### \*\*\* NOTICE OF DECISION \*\*\*

**Case Number:** RNA-DRB-20-01  
**Activity Number:** T20SA00145  
**Review Type:** Rio Nuevo Area (RNA)  
**Project Name:** Farhang & Medcoff  
**Location:** 100 S Church Avenue (Tax Parcel # 117-20-016H)

NORTH ELEVATION | SCALE: 1/8" = 1'-0"

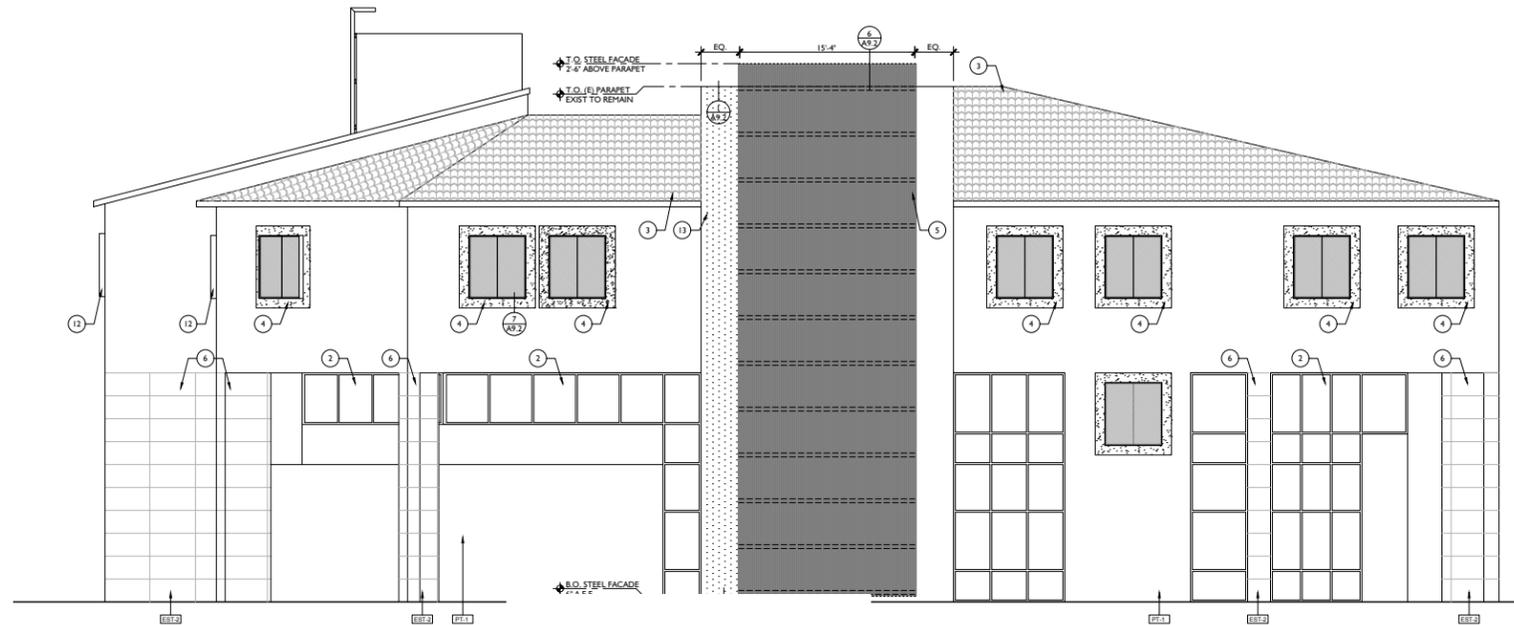
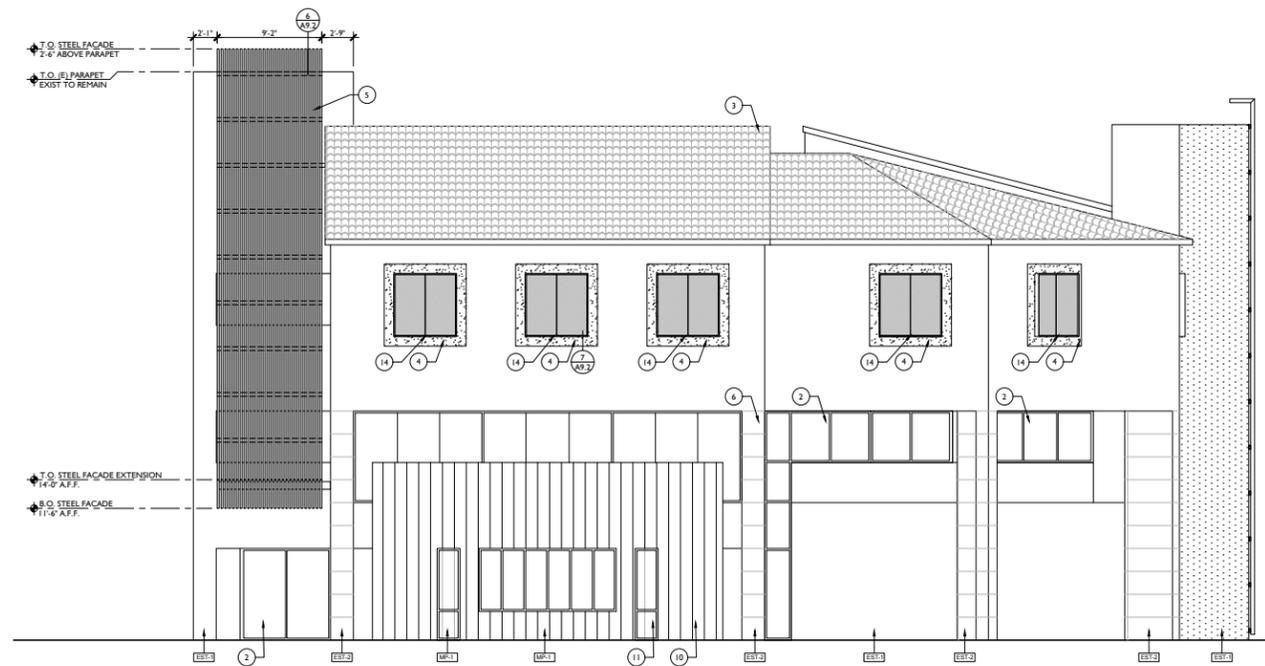
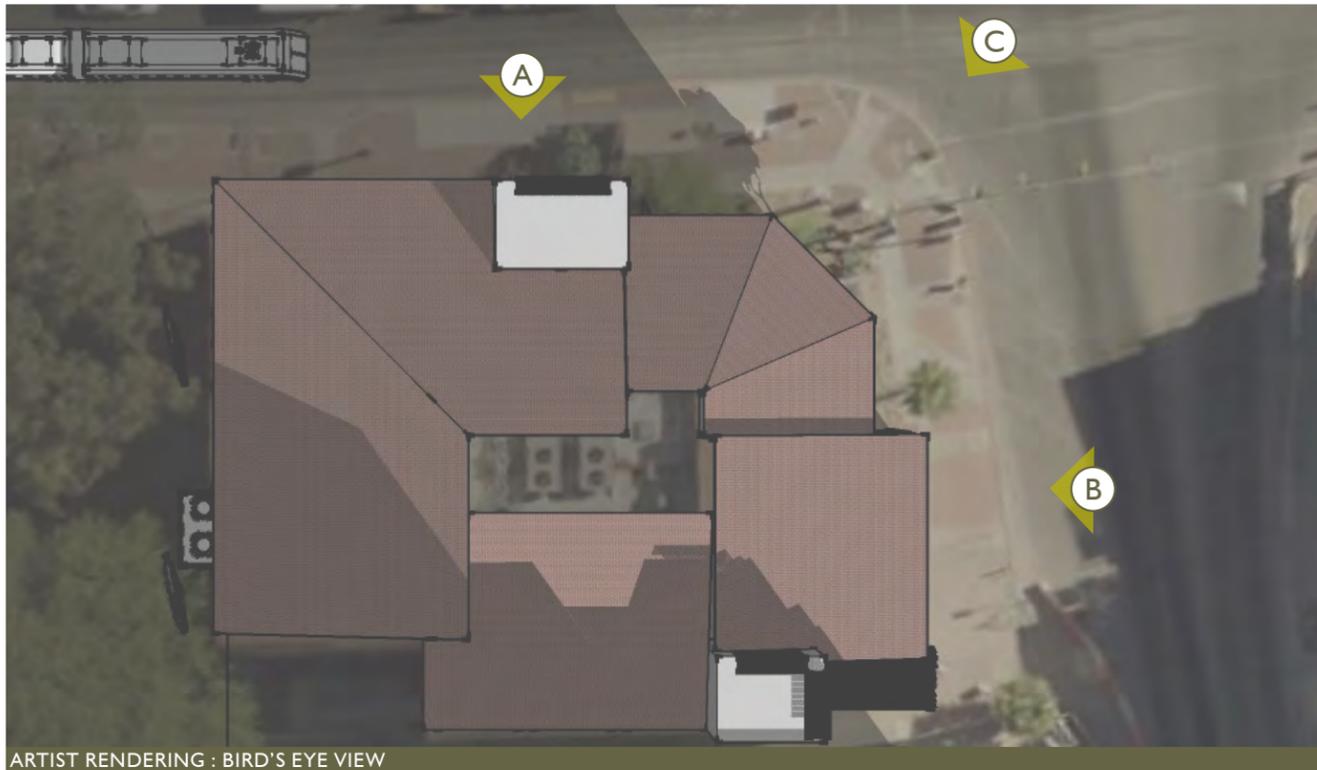
The Design Review Board (DRB) reviewed the proposal on May 22, 2020, for compliance with the Rio Nuevo Area (RNA) design standards pursuant to Unified Development Code (UDC) Section 5.12.7, and recommended approval, requesting that the applicant revise the project plans to show that the second floor window on the north elevation would remain, and to indicate where new outdoor lighting will be provided. The applicant made those revisions to the plans, as requested by the DRB.

Pursuant to provisions of the RNA design criteria and historic review criteria, as listed UDC Sections 5.12.7 the applicant's request is approved, as shown on the submitted plans stamped approved on June 1, 2020.
